# Design Modification Documents

<b>Client Name</b>	AGNICO EAGLE MINES
<b>Project Name</b>	AMARUQ PHASE 2 – IVR D1 DIKE

<b>Contract No.</b>	6127-E-132-003
<b>Contract Name</b>	IVR D1 DIKE CONSTRUCTION
<b>Site Engineering Query Register No.</b>	RFI-01
<b>Topic</b>	ESKER MATERIAL REPLACEMENT

Figure 1 Esker replacement

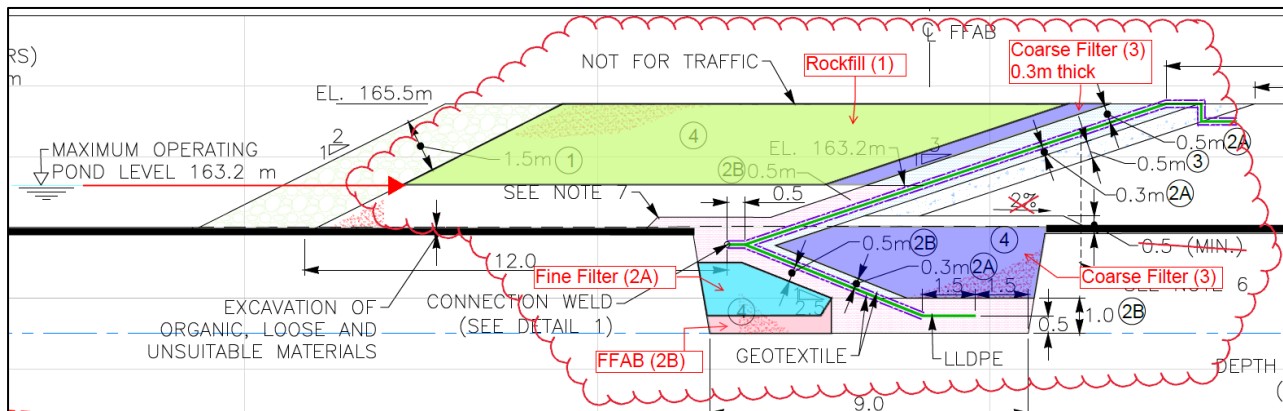
REQUEST
<p><b>Esker material replacement</b></p> <p>The amount of quality esker material available on site is limited and potentially less than what is needed for completing the dike construction as per Revision 0 of the drawings issued for construction. Some of the esker stockpiles have been observed to contain significant amounts of chunky frozen material and ice that might impact the performance of the structure. Backfilling the key trench with such unsuitable ice-rich esker is not acceptable as it would increase the risks of settlement under the liner if the foundation was to undergo thawing conditions. AEM prefers backfilling the key trench with the most appropriate engineered material, at an extra cost, to secure the dike performance while using a maximized amount of suitable esker material in the other required zones.</p> <p>AEM is currently working on sorting out the esker material to separate the good material from the unsuitable one. Ongoing operations and survey indicate that there might not be enough of the acceptable esker material to backfill all the esker zones of the design. The goal of this RFI is to establish accepted equivalence material for the esker and to determine where the good quality esker should be prioritized to ensure an optimal performance of the structure. Esker material that is free of ice, snow and chunk will be used if possible before using the equivalence material.</p> <p>AEM is proposing the following esker substitutions in these zones. These are listed in the order the substitutions would be done (from first zone where esker would be substituted to last, if required).</p> <p>A. <u>Cutoff trench, from 2.5m depth to trench bottom</u>: The low permeability FFAB layer (Fine Filter Amended with Bentonite – Type 2B) will be extended to the full extent of the cutoff trench excavation to improve protection against water infiltration under the liner and to optimize the constructability.</p> <p>B. <u>Cutoff trench upstream zone, from upper FFAB layer to bottom FFAB</u>: Esker will be replaced by compacted Fine Filter material (Type 2A). The use of an engineer fill such as fine filter will improve the performance of the key trench by minimizing settlement potential if the key trench would thaw.</p>

- C. Cutoff trench downstream zone, overlaying the FFAB and Fine Filter layers: Esker will be replaced by Coarse Filter material (Type 3) up to the original ground elevation. The surface of this layer will be flat. There will not be any slope towards the downstream side. The use of an engineer fill such as coarse filter will improve the performance of the key trench by minimizing settlement potential if the key trench would thaw.

- D. Thermal Berm above operational level (above el 163.2): Esker will be replaced by rockfill material (Type 1 material) to provide an upper layer of erosion protection. An additional 0.3m thick layer of Coarse Filter material (Type 3) will be placed as transition material between the rockfill and fine filter liner protection. The suitable esker will be maximized in this zone with the objective to reach the 1:100 year level (El 164.7 m). The minimum placement limit for the esker material is set at the maximum operational level (El 163.2).

Design Variations Requested	Response
<p>A. <u>Cutoff trench, from 2.5m depth to trench bottom:</u> The low permeability FFAB layer (Fine Filter Amended with Bentonite – Type 2B) will be extended to the full extent of the cutoff trench excavation to improve protection against water infiltration under the liner and to optimize the constructability.</p>	<p>For the 3-m-deep cutoff trench, it was initially proposed to use FFAB in the upstream section of the liner, however, AEM proposed esker material with sufficient fines due to the available quantity of esker on site. Substituting the esker for FFAB (Type 2B) will meet the design requirements. However, the thickness should be a minimum of 0.5 m. This modification is approved.</p>
<p>B. <u>Cutoff trench upstream zone, from upper FFAB layer to bottom FFAB:</u> Esker will be replaced by compacted Fine Filter material (Type 2A). The use of an engineer fill such as fine filter will improve the performance of the key trench by minimizing settlement potential if the key trench would thaw.</p>	<p>For the 3-m-deep cutoff trench, it is initially proposed to use FFAB in the upstream section of the liner, however, AEM proposed esker material with sufficient fines due to the large available quantity of esker material on site. Substituting the esker for fine filter (Type 2A) will meet the design requirements. This modification is approved.</p>

<p>C. <u>Cutoff trench downstream zone, overlaying the FFAB and Fine Filter layers:</u></p> <p>Esiker will be replaced by Coarse Filter material (Type 3) up to the original ground elevation. The surface of this layer will be flat. There will not be any slope towards the downstream side. The use of an engineer fill such as coarse filter will improve the performance of the key trench by minimizing settlement potential if the key trench would thaw.</p>	<p>Due to the coarseness and associated high permeability of the Type 3 material, the use of this material may adversely impact the thermal regime in the cutoff trench and the performance of the dike structure.</p> <p>This modification is not approved.</p>
<p>D. <u>Thermal Berm above operational level (above el 163.2):</u></p> <p>Esiker will be replaced by rockfill material (Type 1 material) to provide an upper layer of erosion protection. An additional 0.3m thick layer of Coarse Filter material (Type 3) will be placed as transition material between the rockfill and fine filter liner protection. The suitable esiker will be maximized in this zone with the objective to reach the 1:100 year level (El 164.7 m). The minimum placement limit for the esiker material is set at the maximum operational level (El 163.2).</p>	<p>Reduction of the esiker material thickness will impact the thermal regime in the upstream section of the dike due to the coarse nature of the rockfill in comparison to the esiker material. The performance of the dike may be impacted, especially if the Attenuation Pond water level rises above the maximum operational level (El. 163.2 masl). Additional thermal modelling could allow an estimation of the thermal regime using rockfill material instead of esiker but the inherent limitations of the model regarding convective heat transfers would hence affect the level of confidence of the results.</p> <p>This modification is not approved.</p>

Figure 1 Liner connection weld elevation vs original ground level

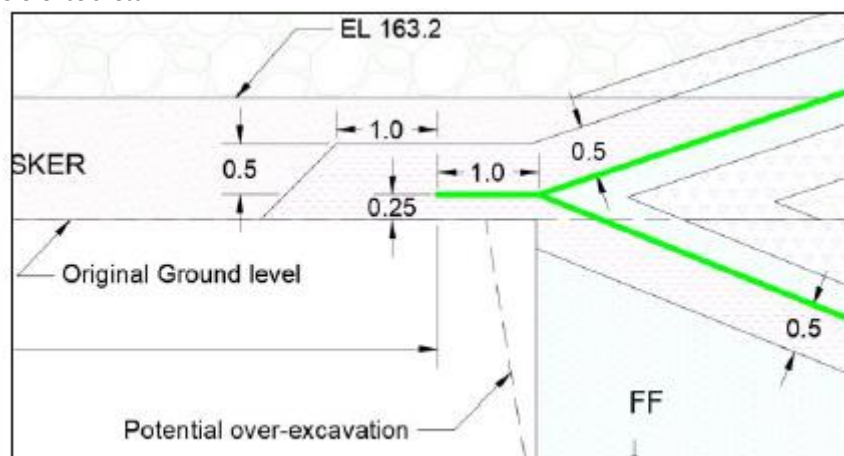
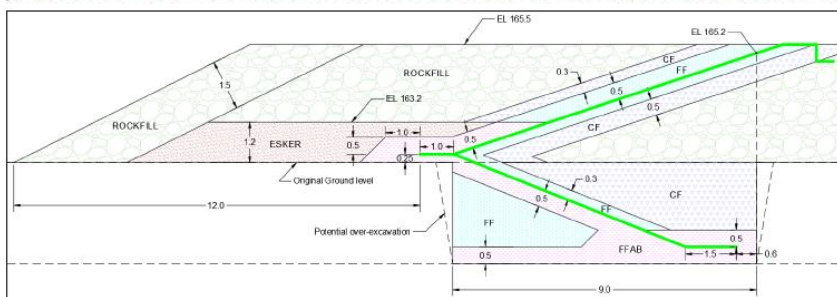
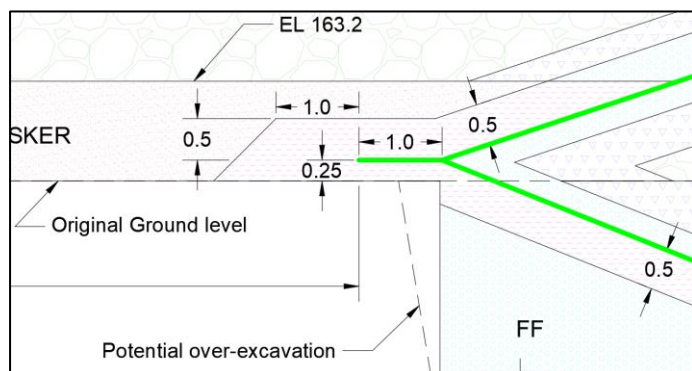
To improve the performance of the key trench some changes are proposed to its geometry and the location of the liner joint.

The connection weld will be 0.25m above the original ground elevation, embedded in the Fine Filter Amended with Bentonite layer (0.5m of FFAB above the connection weld and 0.25 to 0.5m below the weld depending on the amount of material removed for surface preparation) – Refer to Fig 5. This change will improve the dike performance by allowing a proper installation of the liner at the connection weld and will ensure an optimal protection to avoid water ingress to the key trench.

All the geometry of the cutoff trench with respect to the liner will remain as per design except the distance between the liner and the downstream side of the trench, that will change from 1.5m to 0.6m to keep the excavation 9m wide (Fig 6). Also, because of moving the connected weld 0.75m higher, the excavation will be slightly shifted downstream. This will also be beneficial to the dike performance and will ensure that the engineered cutoff trench extends upstream under the upper liner (from connection weld to elevation 165.2). Such an improved geometry will ensure the integrity of the liner system by minimizing the risks of under-liner settlement

<b>2. RESPONSE BY ENGINEERING (SNC-LAVALIN)</b>
<b>Response</b>
<p>In the design, the liner connection weld was provided in the cutoff trench for protection and to have a thick FFAB layer above to assist in the thermal protection and to reduce the seepage potential. Raising the connection weld above the original ground will help facilitate construction.</p> <p>It is recommended that the thickness of the FFAB be a minimum of 0.5 m thick (above the prepared foundation) in the liner connection area to avoid a potential liner puncture at the corner of the cutoff excavation. Also, it is recommended that the liner be extended 1.0 m beyond the potential over-excavation (thus increasing the width of the liner connection (i.e., &gt; 1.0 m)) including the placement of 1.0 m wide FFAB beyond the excavation wall.</p> <p>This modification is approved in conjunction with the implementation of the recommendations.</p>

Figure 1 Surface preparation upstream of the key trench

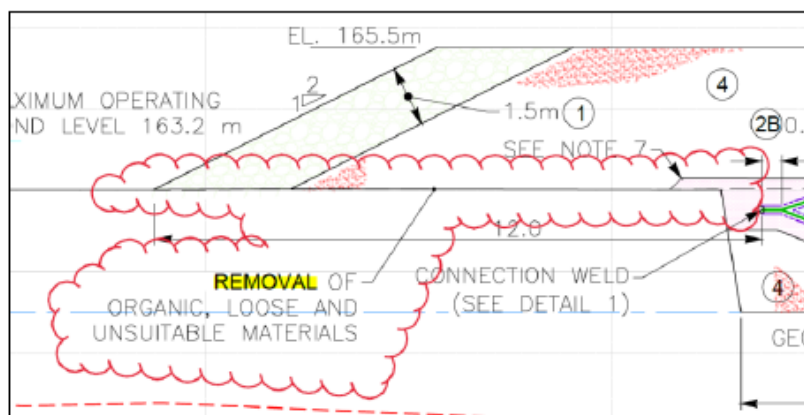
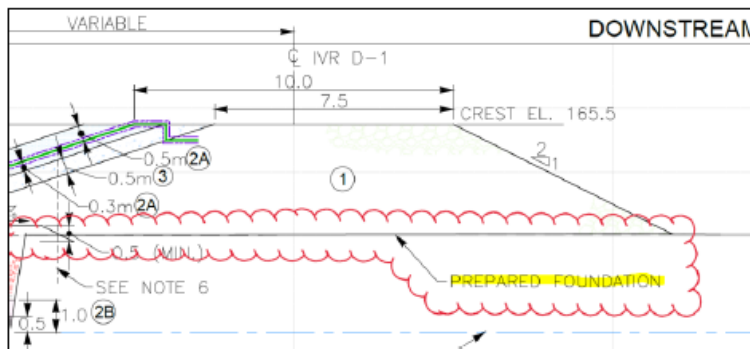
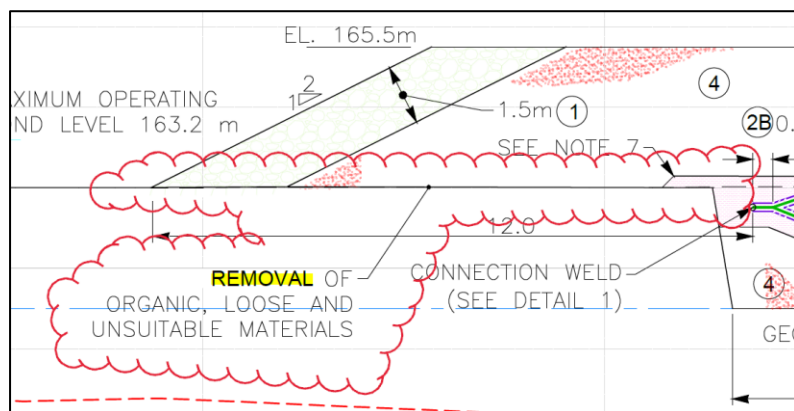
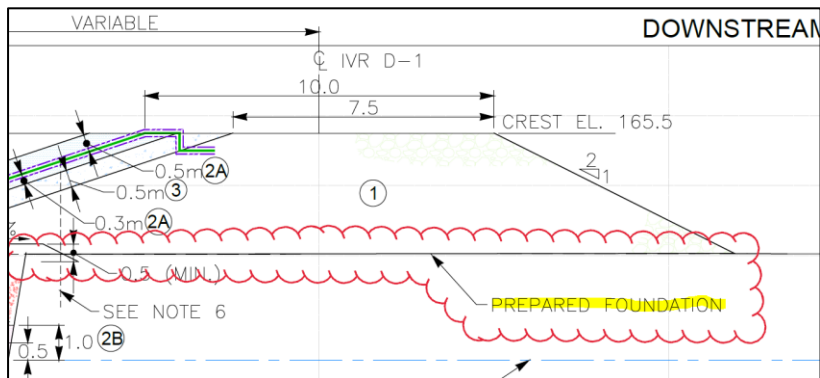
The construction drawings mention the need for excavation of organic, loose and unsuitable material and show an excavation cut without indicating any excavation dimension.

To simplify the construction in the field it is proposed that the surface preparation outside of the key trench include removal of organic material, boulders, snow, ice, loose and unsuitable materials (Fig. 3 and 4). As a results material will be stripped and removed but without a systematic excavation at a fixed depth. To ensure a suitable dike performance the foundation condition will be inspected prior to material placement and approved by the QA and QC representative.

<b>2. RESPONSE BY ENGINEERING (SNC-LAVALIN)</b>			
<b>Response</b>			
The proposed approach is acceptable.

Figure 1. Thermal Berm width

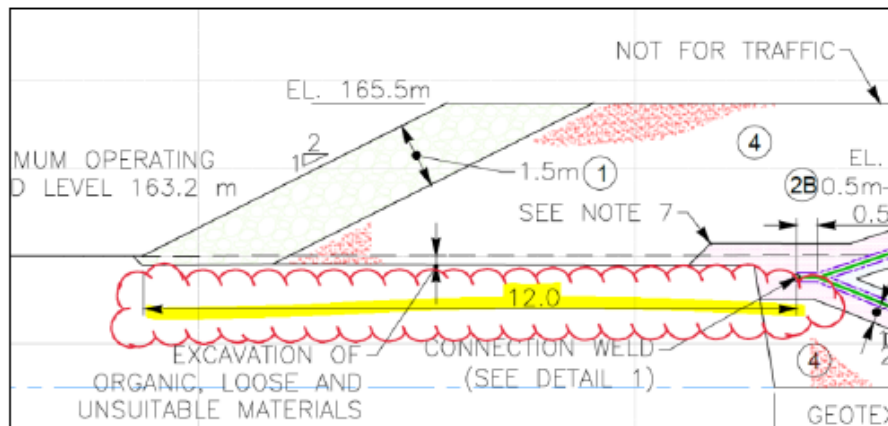
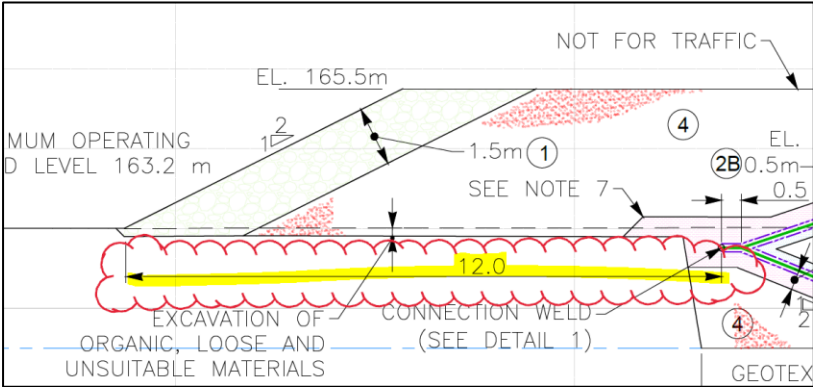
The 12m wide upstream thermal berm will include the 1.5m thick upstream rockfill shell of the thermal berm. The 12m will extend from the upstream toe of the dike to the liner connection weld (Fig. 1). Within the 12m, the rockfill shell remains 3.35m wide and the esker fill will be 8.65m wide. As per the thermal model report this change is not expected to impact the performance of the structure. This change is requested to optimize the dimension of the thermal berm and is not expected to impact the dike performance as per the available thermal modeling results.

REQUEST
<p>The 12m wide upstream thermal berm will include the 1.5m thick upstream rockfill shell of the thermal berm. The 12m will extend from the upstream toe of the dike to the liner connection weld (Fig. 1). Within the 12m, the rockfill shell remains 3.35m wide and the esker fill will be 8.65m wide. As per the thermal model report this change is not expected to impact the performance of the structure. This change is requested to optimize the dimension of the thermal berm and is not expected to impact the dike performance as per the available thermal modeling results.</p>  <p><b>Figure 1. Thermal Berm width</b></p>

As highlighted in the thermal analyses technical note, the thermal effect of reducing the width of the berm relies on a phenomenon that is not taken into consideration in the study, that is convective heat transfer. A narrower berm, especially when in conjunction with using rockfill material, could lead to higher water ingress close to the cutoff trench, which will bring some heat in this area. The actual thermal modelling of this proposed modification of the dike design cannot be conducted with certainty for the reason mentioned previously; that is why a 12-m-wide esker berm, excluding the 1.5-m-thick rockfill in the upstream slope, was proposed in the initial design. The results from the thermal modelling also shown that

the construction of a wider berm would promote cooling of the upstream foundation (especially close to the cutoff trench), thus reducing possibility of thawing of the foundation and development of potential seepage pathways towards the cutoff trench.

SNC-Lavalin recommends keeping the same thermal berm width as initially designed. However, if AEM decides to proceed with reducing the overall width, proper monitoring points (temperature and elevation) should be put in place to follow the performance of the structure and that an appropriate mitigation plan and measures be developed in case there is any issue with the performance of the dike.

Figure 3 – FFAB placement from station 0+435 to the East abutment and from the West abutment to station 0+080, only

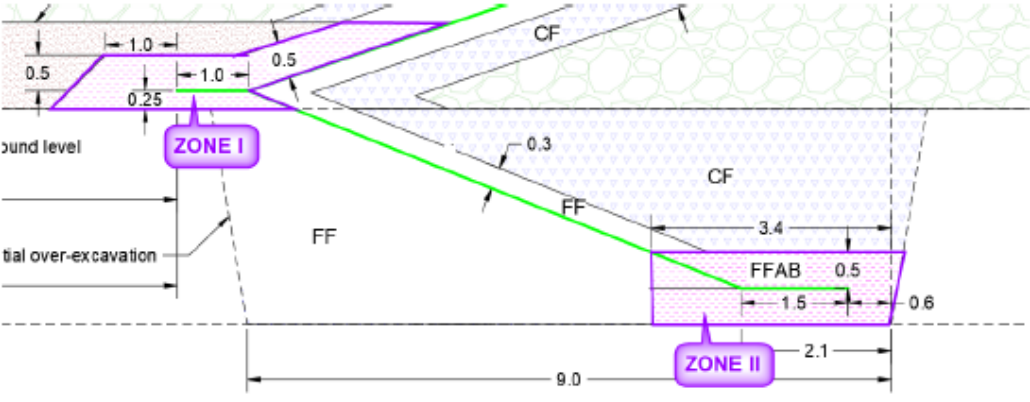
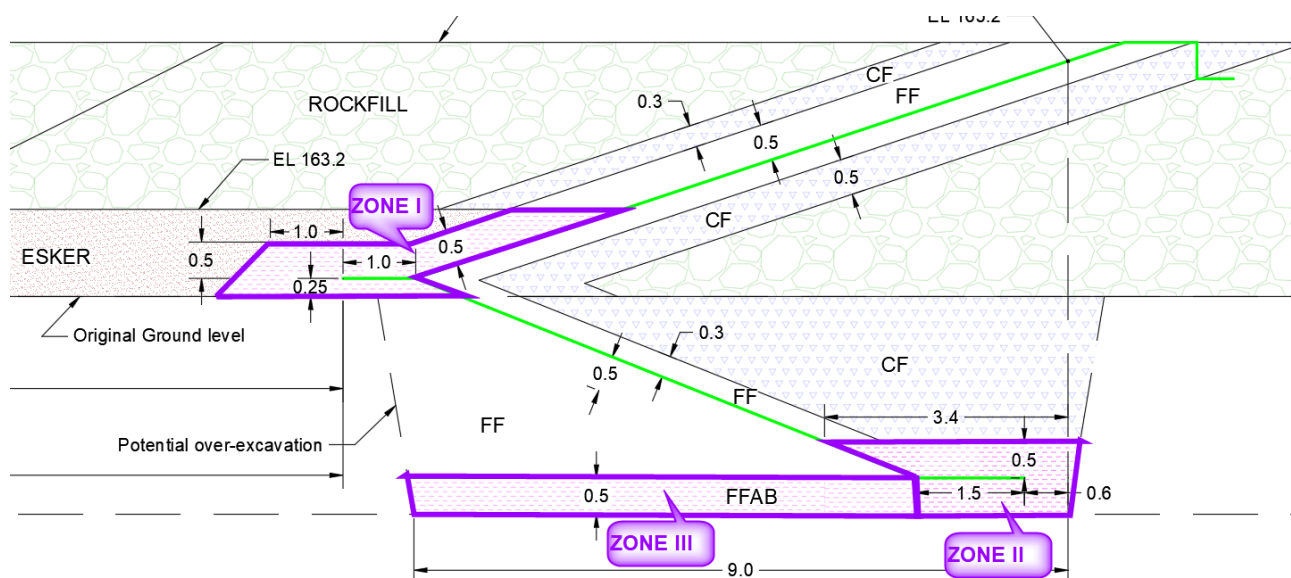
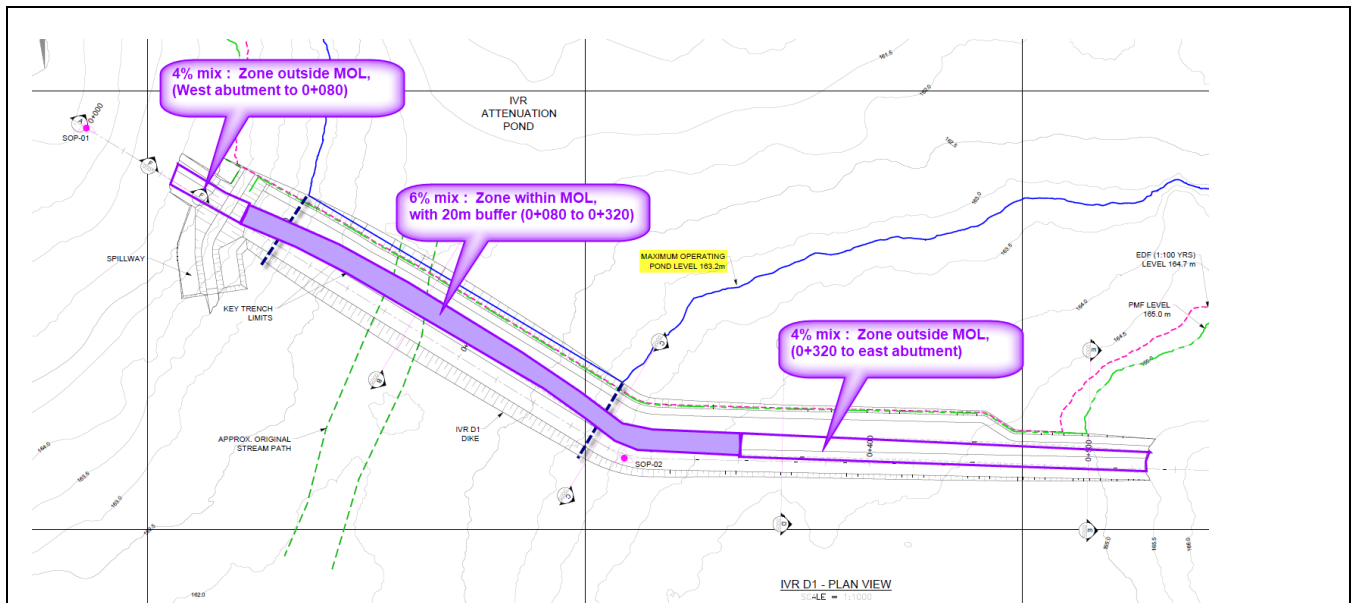
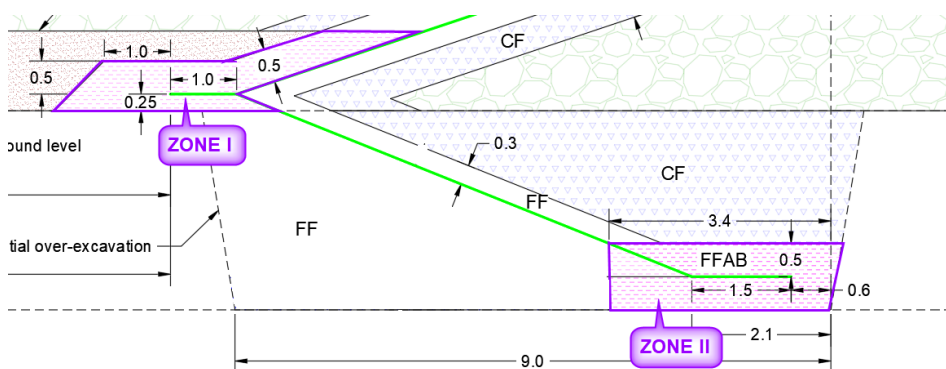
In order to build a performing structure with the amount of bentonite available on site, an optimization scenario of the FFAB zones within the dike is proposed. It has been discussed internally between the all concerned stakeholders and with the QA representative. The scenario retained and agreed between the parties is the subject of the current RFI. AEM is proposing to modify the zone where FFAB will be placed to optimize the available quantity while ensuring a good performance of the structure.

The water retention performance of IVR Dike relies on its impermeability system. The primary impermeable element of this system is the LLDPE liner. As a second line of defense, the expected thermal regime of the structure is such that the foundation is to remain frozen year-round (refer to the design report and thermal modeling sections for further details). AEM is of the opinion that the low permeability FFAB material placed within the structure adds robustness to the design and suggests to optimize the available bentonite as follows. The proposal complies with the quantity of bentonite remaining on site, as of March 10<sup>th</sup>, 2021.

AEM suggests keeping the FFAB bentonite mix ratio at 6% within the MOL zone as per design specification and using a 4% mix ratio outside of the MOL zone. This change of bentonite mix ratio outside of the MOL is not expected to affect the structure performance. The likelihood of having water above the MOL for a sustained period of time is quite low and such a high water level would most probably occur at freshet when the structure and foundation will be at its coldest temperature.

Also, as per a phone meeting held on March 22<sup>nd</sup> 2021 involving SNC-Lavalin (Anh-Long Nguyen – Design Engineer), AEM (Thomas Lepine – Engineer of Record Nunavut, Laurier Collette – Geotechnical Engineer), Golder (Yves Boulianne, Marion Habersetzer), all parties agreed that outside of the MOL, FFAB material will be specifically placed in zone I and zone II only, from station 0+435 to the East abutment and from the West abutment to station 0+080. This is to further optimize FFAB placement because of a limited amount of bentonite available on site. Figure 3 illustrates where the FFAB will be placed in this specific part of the key trench. As of 2021-03-22, the remaining of the key trench outside the MOL is already backfilled (from 0+320 to 0+435).

<b>2. RESPONSE BY ENGINEERING (SNC-LAVALIN)</b>
<b>Response</b>
<p>Considering the limited quantity of bentonite on site, the proposed modifications is acceptable.</p> <p>Note that the layer of FFAB upstream of the liner has also been removed. This is still acceptable since the liner will remain the primary barrier to infiltration in the key trench as per design. AEM will have to ensure the liner is properly installed and have all of the relevant testings and QC/QA reports to demonstrate this.</p>

Figure 1 – FFAB placement from station 0+435 to the East abutment and from the West abutment to station 0+080, only

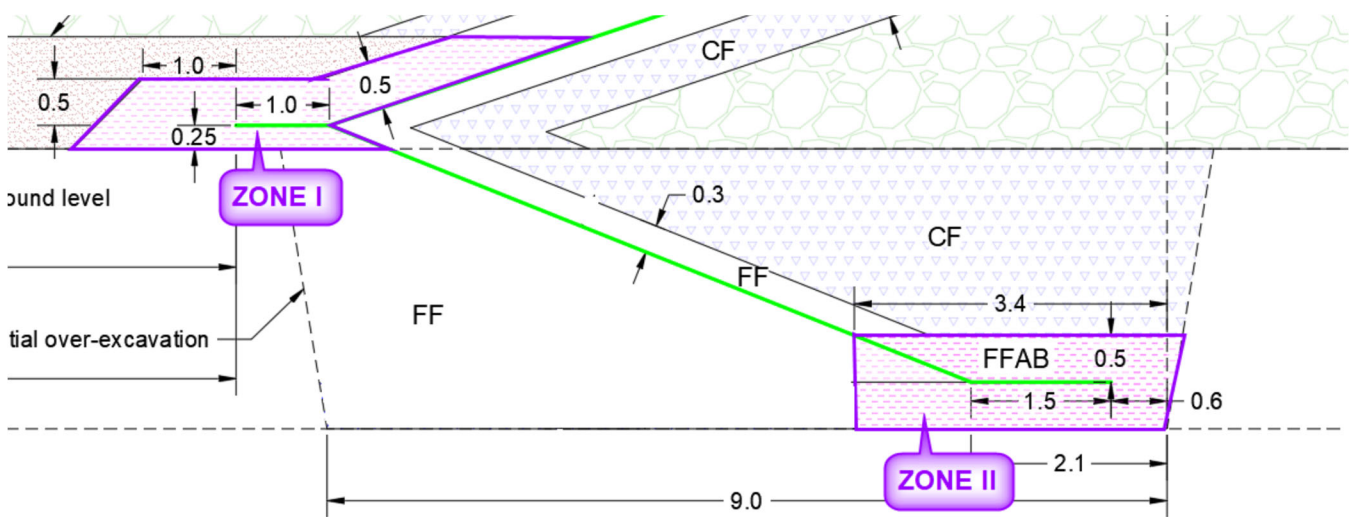
As further detailed in RFI-05, upon a phone meeting held on March 22<sup>nd</sup> 2021 involving SNC-Lavalin (Anh-Long Nguyen – Design Engineer), AEM (Thomas Lepine – Engineer of Record Nunavut, Laurier Collette – Geotechnical Engineer), Golder (Yves Boulianne, Marion Habersetzer), all parties agreed that outside of the MOL, FFAB material will be specifically placed in zone I and zone II only, from station 0+435 to the East abutment and from the West abutment to station 0+080. This is to further optimize FFAB placement because of a limited amount of bentonite available on site. The shortage is caused by the greater amount of FFAB placed so far to fill the bedrock overbreak of the key trench floor (about 100% of additional FFAB required). Figure 1 illustrates where the FFAB will be placed in this specific part of the key trench. As of 2021-03-22, the remaining of the key trench outside the MOL is already backfilled (from 0+320 to 0+435).

Considering the limited quantity of bentonite on site, the proposed modifications is acceptable.

Note that the layer of FFAB upstream of the liner has also been removed. This is still acceptable since the liner will remain the primary barrier to infiltration in the key trench as per design. AEM will have to ensure the liner is properly installed and have all of the relevant testings and QC/QA reports to demonstrate this.
